Response to NCDEQ Comments on the Brevard Conceptual Remedial Action Plan

Soil Cover Verification
Response to NCDEQ Comments
Brevard Site
Cedar Mountain, North Carolina

Figure 1

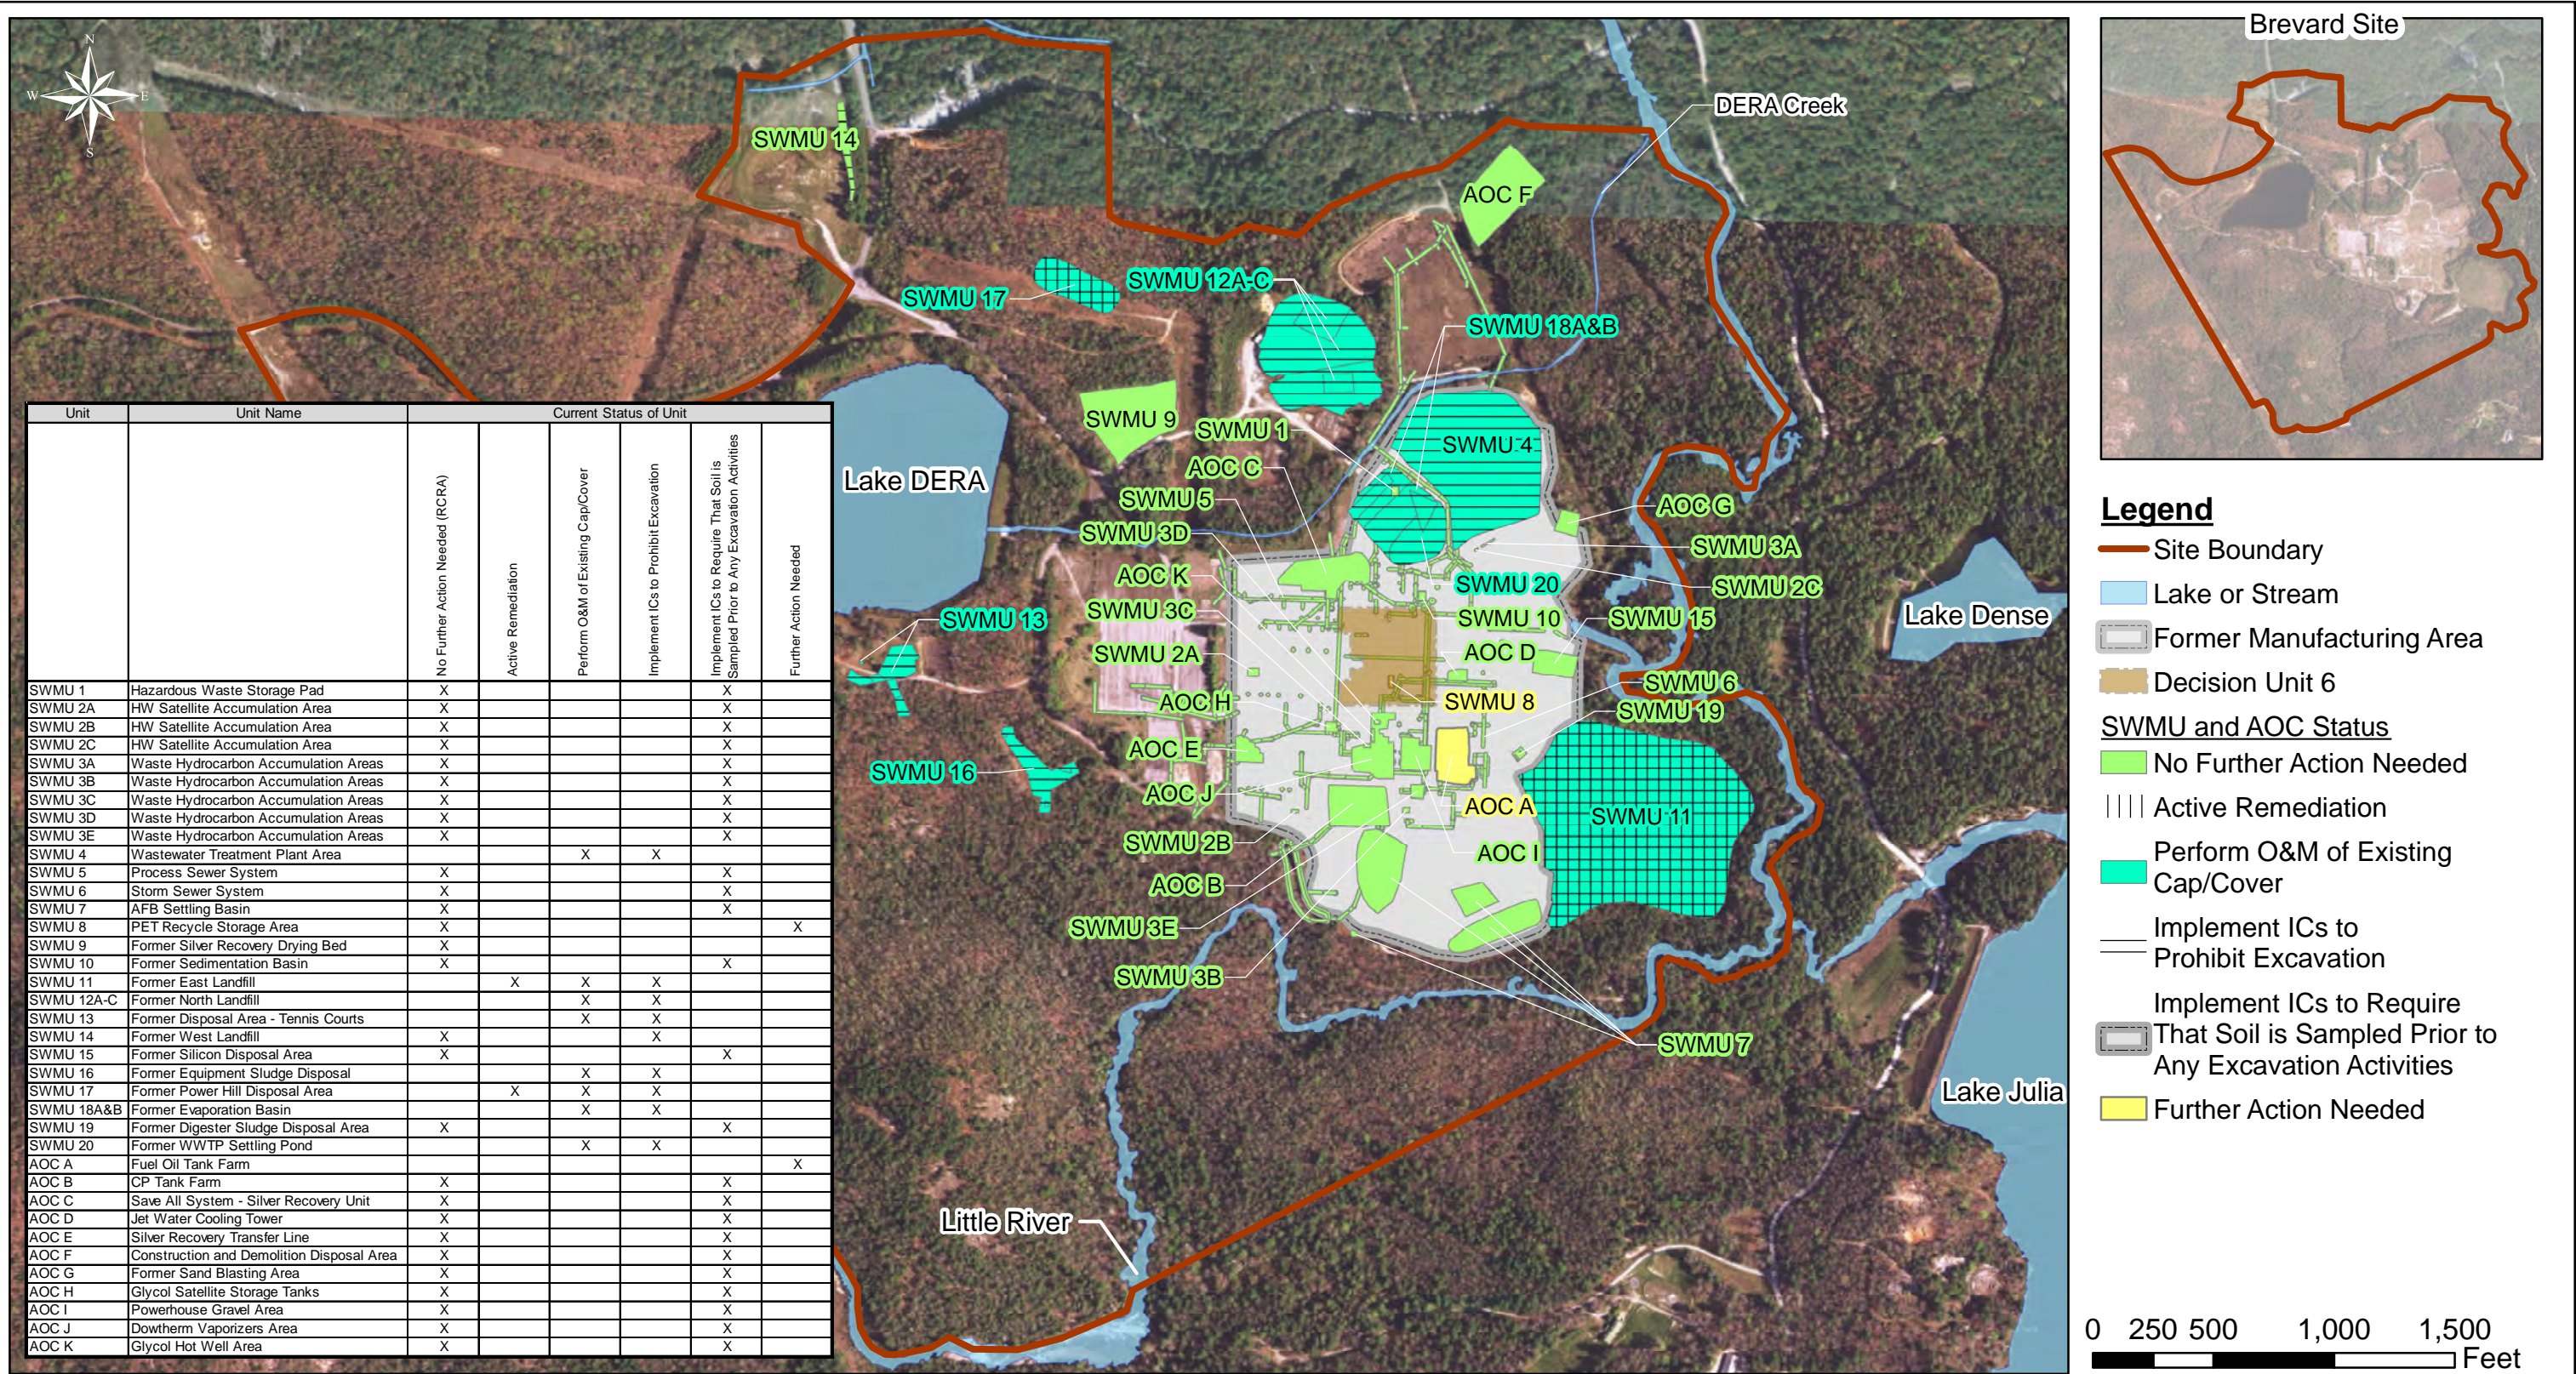
NCDEQ Comment	DuPont Response
<p>1.</p> <p>Section 2.6.6 – As indicated in HWS comments on the Remedial Investigation Workplan (RIW) and the Remedial Investigation Report (RIR), data from boring logs advanced during the Phase II RFI and during implementation of the RIW indicate there may not be sufficient cap/cover at some of the SWMUs where waste remains in place. During a December 2015 meeting, DuPont personnel indicated they would consider installation of additional cover materials (e.g. gravel at SWMU 13 of sufficient quantity to use as a potential parking area) at some site SWMUs. If DuPont is still considering this plan, it should be indicated in the RAP.</p>	<p>DuPont is not considering installing additional cover materials at any SWMUs on the Site. During the final Site field investigation, soil cores were collected from the following SWMUs: SWMUs 4, 12A, 12B, 12C, 13, 15, 16, 18A&B, 19, and 20 (see Section 5.1.2 of the RIR). The results of the final field investigation indicated that, despite the presence of some miscellaneous debris, adequate soil covers were intact at these SWMUs (see Figure 1). The miscellaneous debris observed in the soil cores were from three of the SWMUs:</p> <ul style="list-style-type: none"> • SWMU 12B (Former North Landfill): Green turquoise plastic was found in one of six soil cores (SWMU-12B/C-CB-3). • SWMU 15 (Former Silicon Disposal Area): Plastic, high purity silicone fragments, and/or other materials were found in three of 10 soil cores (SWMU-15-SS-1, SWMU-15-SS-2, SWMU-15-SBS-1). • SWMU 18B (Former Disposal Area 8 for evaporation basin wastewater containing zinc chloride): PVC pipe, a soda can, pipe jacket with Tedlar coating, and a small piece of metal were found in one of three soil cores (SWMU-18B-CB-1). <p>This topic was discussed further at a meeting on April 7, 2016 in Raleigh with NCDEQ and NCDA&CS. NCDEQ indicated that they would consider this response further and provide a recommendation in the near future.</p>

Figure 2
 (Revised RAP Figure 2-9)

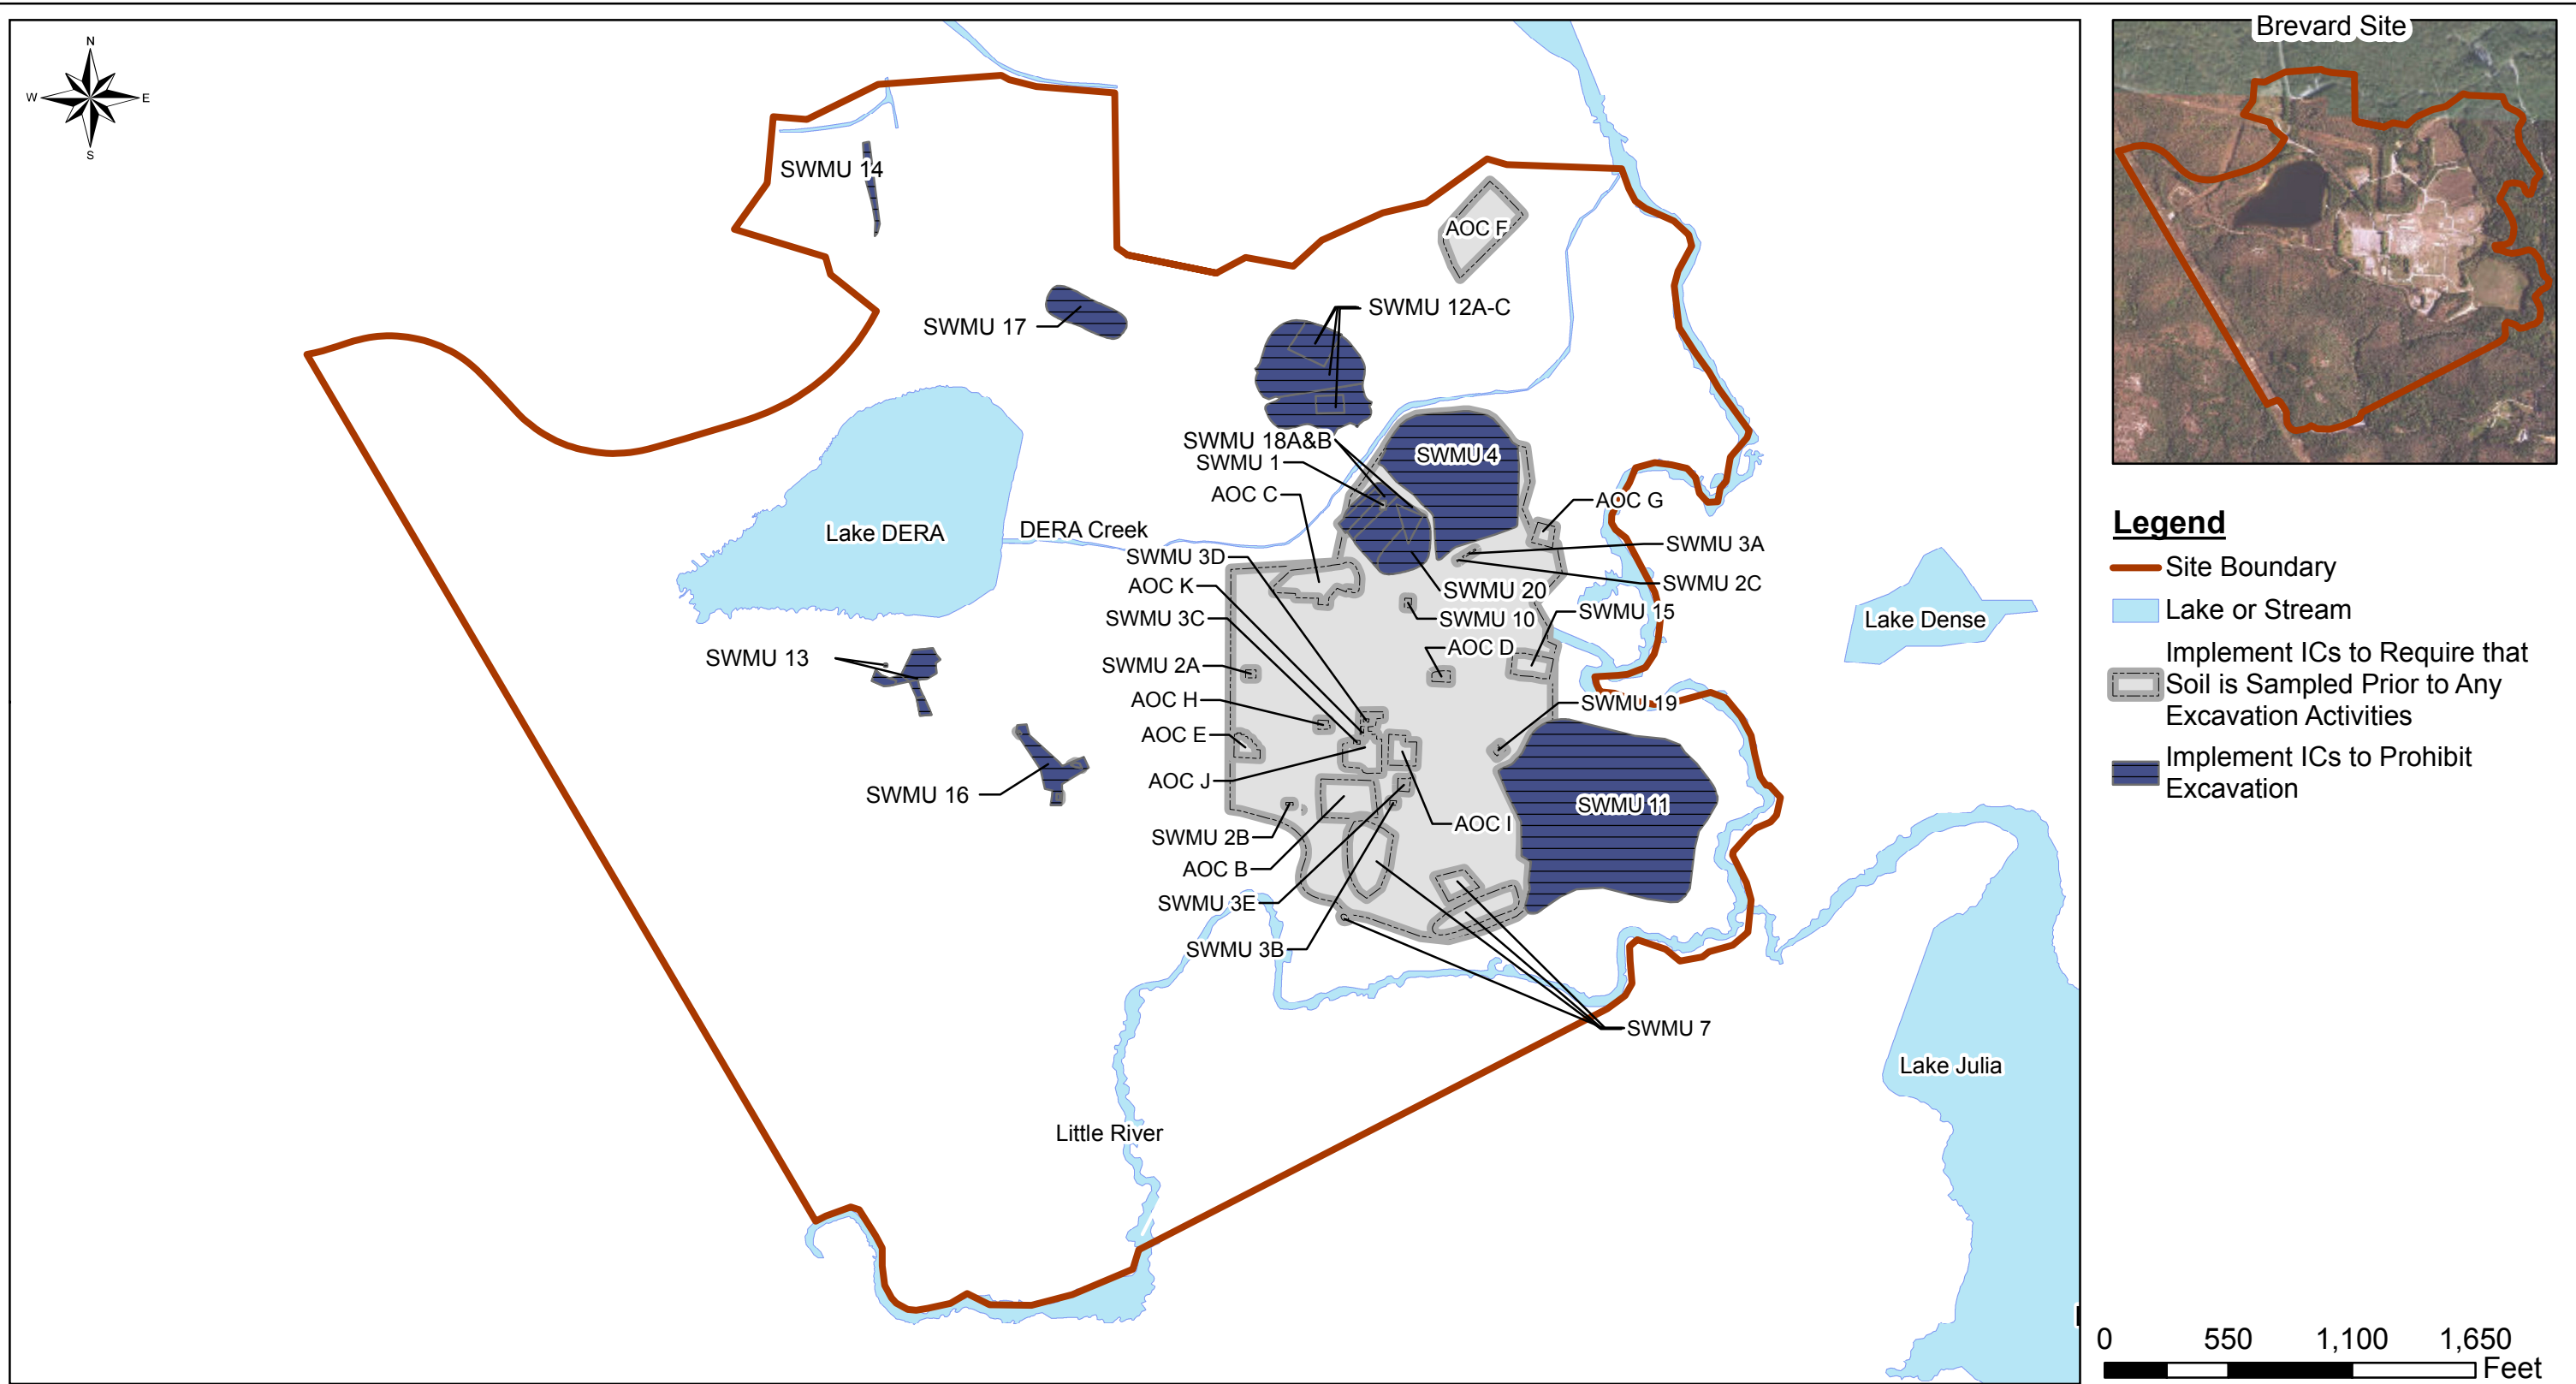
<p>5. Section 2.8 – AOC 2C should be moved from NFA to the category that requires notification and sampling prior to excavation.</p>	<p>Before the RAP is submitted to NCDEQ, Section 2.8 and Figure 2-9 will be revised to clarify that all SWMUs and AOCs located in the former manufacturing area, including AOC 2C, are considered Test Before Dig Areas and must be sampled prior to any excavation activities (see Figure 2 and Attachment 1).</p>
<p>6. Section 2.8 - AOC F is listed as NFA in the Permit but is listed in the RAP as an area where excavation is prohibited. The status of AOC F should be clarified.</p>	<p>Before the RAP is submitted to NCDEQ, AOC F will be reassigned from a No Dig Area to a Test Before Dig Area (i.e., Implement ICs to Require that Soil is Sampled Prior to Any Excavation Activities Area), based on discussions with NCDEQ and NCDA&CS (see Figures 2 and 3).</p>
<p>7. Section 2.8 – See comment 3.</p>	<p>Before the RAP is submitted to NCDEQ, Section 2.8 and Figure 2-9 will be revised to clarify that all of the SWMUs and AOCs located in the former manufacturing area are considered Test Before Dig Areas and must be sampled prior to any excavation activities (see Figure 2 and Attachment 1).</p>

<p>8. Section 2.8 - AOC A is listed as Further Action Needed in this Section. The status of this AOC should be clarified.</p>	<p>Before the RAP is submitted to NCDEQ, Section 2.8 and Figure 2-9 will be revised to clarify that all of the SWMUs and AOCs located in the former manufacturing area are considered Test Before Dig Areas and must be sampled prior to any excavation activities (see Figure 2 and Attachment 1).</p>
